**MENDOCINO HISTORICAL REVIEW BOARD
STAFF REPORT**

**DECEMBER 2, 2019
MHRB_2019-0011**

PROJECT DESCRIPTION: Mendocino Historical Review Board request to (1) remove and replace approximately 150 feet of concrete sidewalk along the south side of the building to bring into ADA compliance which includes a concrete driveway approach to connect the sidewalk on the south side of the building with the existing sidewalk along the parcels to the west of the site, (2) remove the existing planters along the east side of the building and replace with 50 feet of ADA compliant concrete sidewalk with asphalt placed along the edge where it leads into the existing on-street parking, and (3) replace existing ATM with a new ADA compliant machine. Associated improvements include truncated domes at the southeastern corner of the parcel where the sidewalks meet the crosswalk. Concrete finish will be either exposed aggregate or brush finish, as determined by the Review Board.

STREET ADDRESS: 10500 Lansing Street, Mendocino (APN 119-234-07, 119-234-04, 119-234-06).

UKIAH STREET OVERALL SITE AND GRADING PLAN

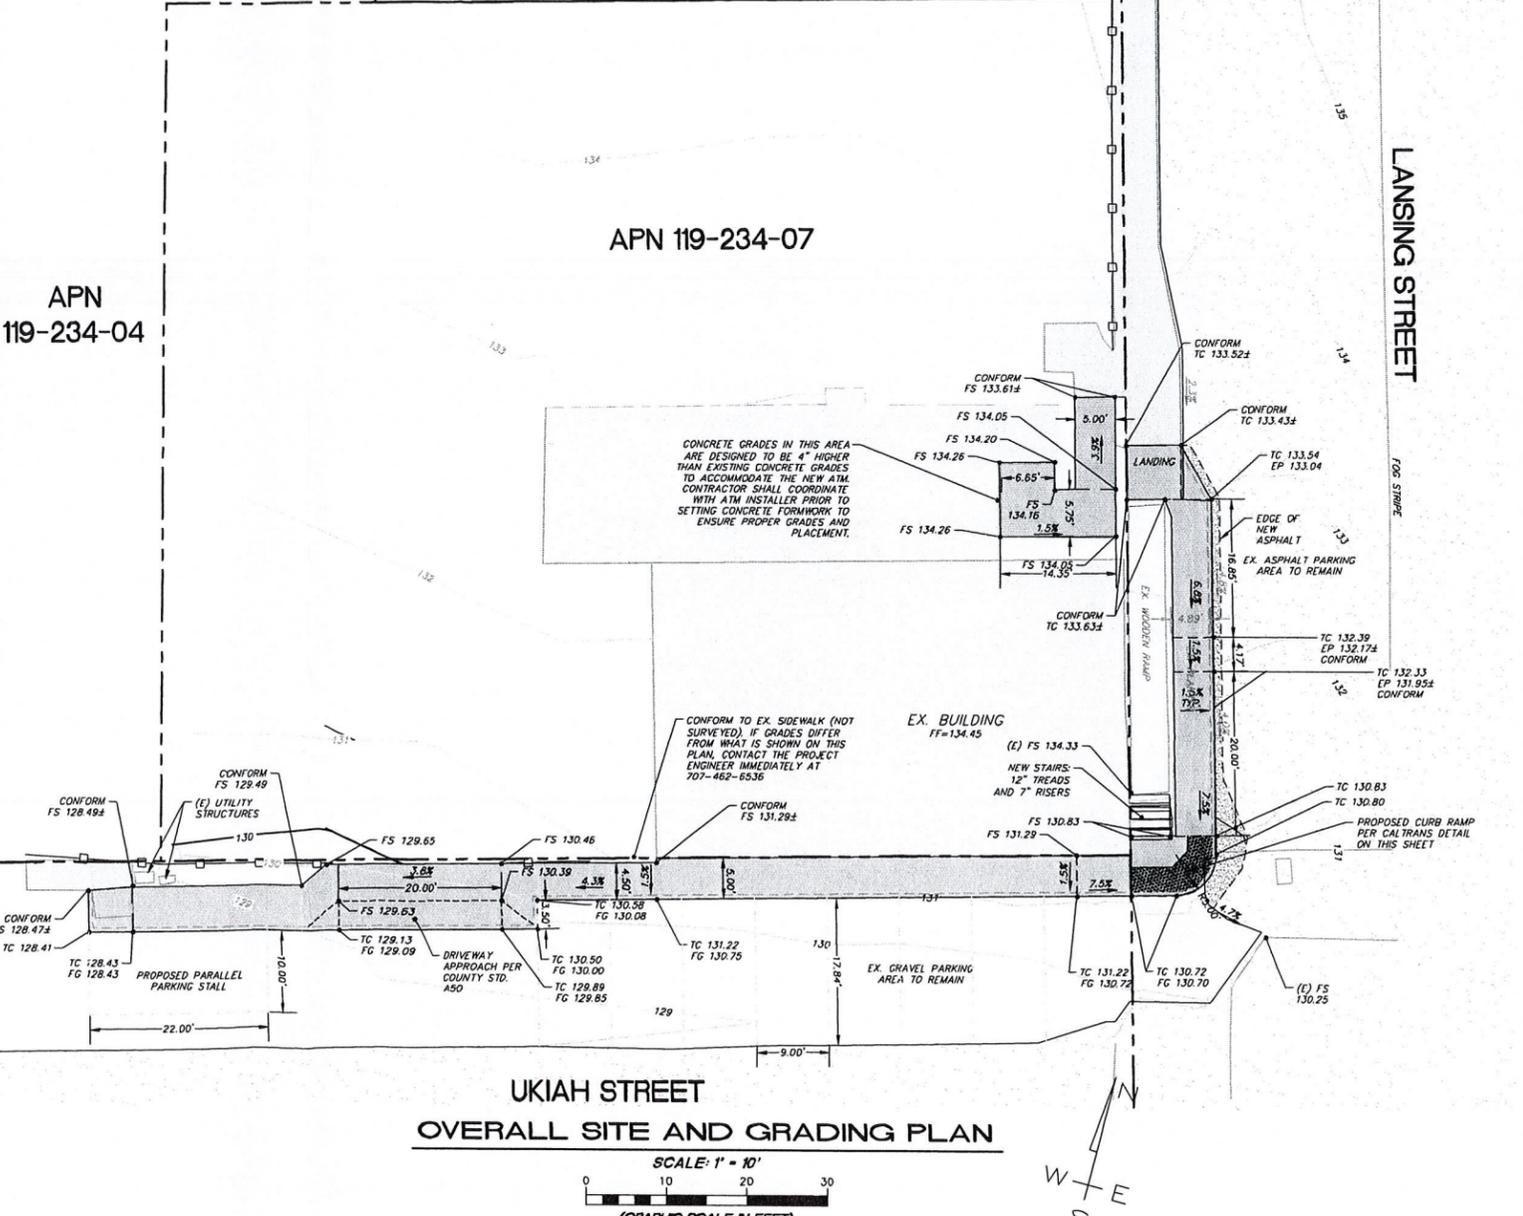
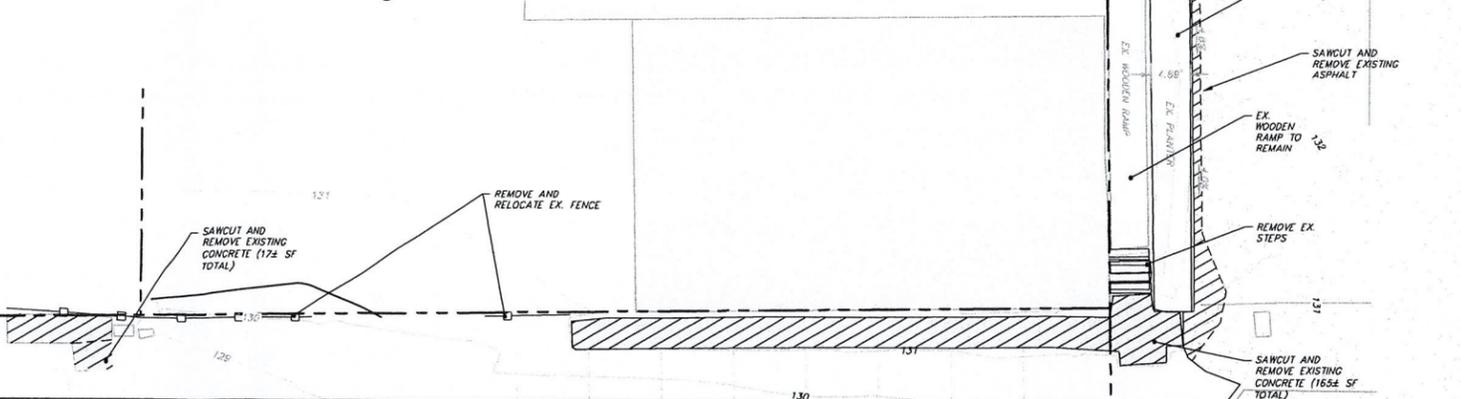
Proposed ADA Sidewalks: The sidewalk replacement on the south side of the building may require some grading to ensure proper grade of the sidewalk and includes the installation of a driveway encroachment in order to provide a continuous surface connecting the existing sidewalk on parcels to the west of the subject parcel.

The sidewalk on the east side of the building requires removal of the existing planter. The existing wood ramp would remain. Some grading may be required to ensure proper grade of the sidewalk and asphalt will be installed along the edge to provide transition between the existing parking areas and the sidewalk.

The applicant has offered that the concrete could either be finished with exposed aggregate or brushed concrete.

Truncated domes are required for ADA compliance at the southeastern corner of the building where the two sidewalks meet with the existing crosswalks.

7. Any Building Permit request shall include MHRB Permit 2019-0011 (attached to or printed on the plans submitted).
8. Concrete sidewalks shall be finished with either exposed aggregate or brushed concrete, as determined by the Review Board.
